# Moorebank Precinct **East** - Stage 2 Proposal

Response to Submissions - SSD 16\_7628

## Response to Submissions Report

SSD 16\_7628

Figure 6-1: Amendments to the Proposal

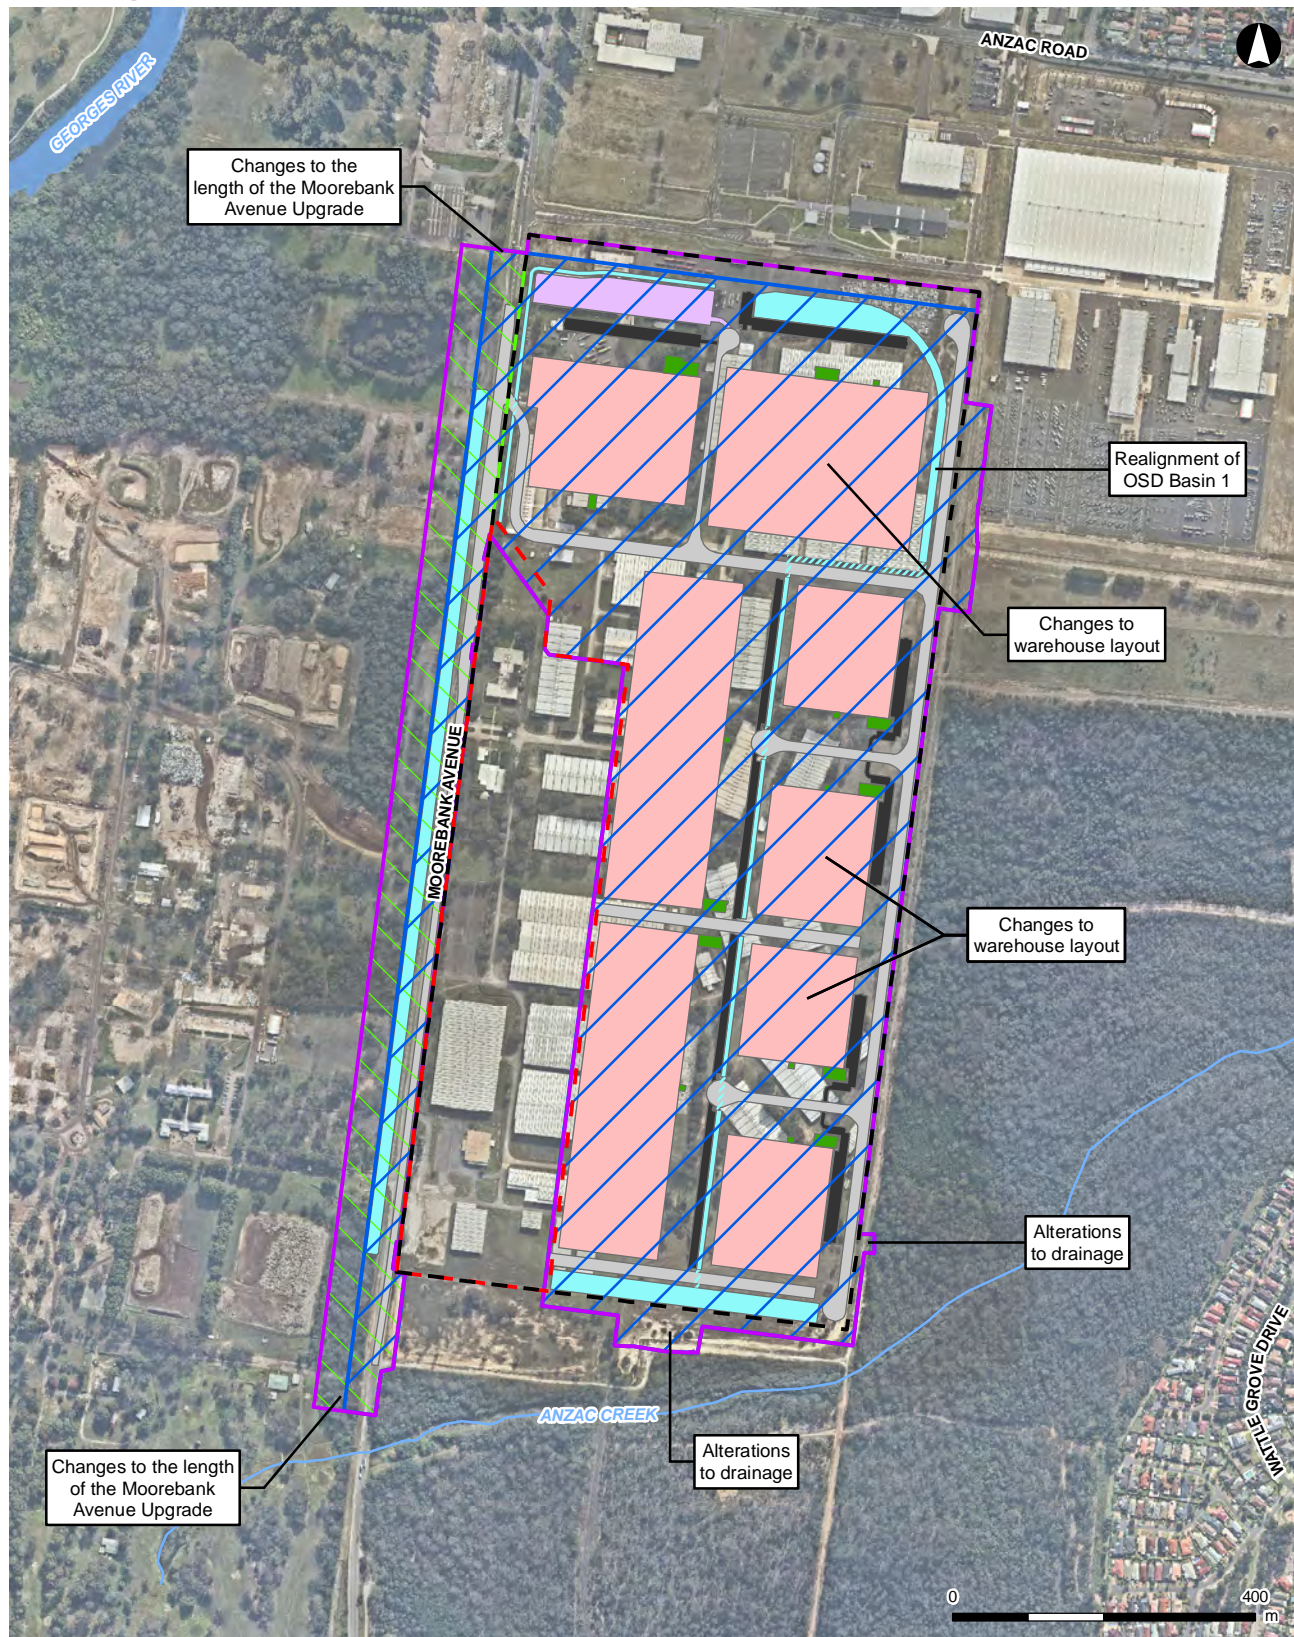
To respond to issues raised by NSW DPI on the EIS and as part of design development, the stormwater and drainage design has been modified as follows:

- Conversion of the southern drainage swale presented in the EIS to a fill mound that would direct surface flows away from the MPE site.
- Removal of the southern drainage channel and outlet to Anzac Creek.
- Provision of a fill batter along the southern boundary of the MPE site.
- Inclusion of a spillway along the eastern boundary of the MPE site immediately south of the south-eastern drainage outlet to manage flows during a PMF event.

Modifications to the project boundary (construction and operational areas) would be required to accommodate the above changes. The Amended construction and operational areas and realigned OSD and spillway are shown in Figure 6-1.
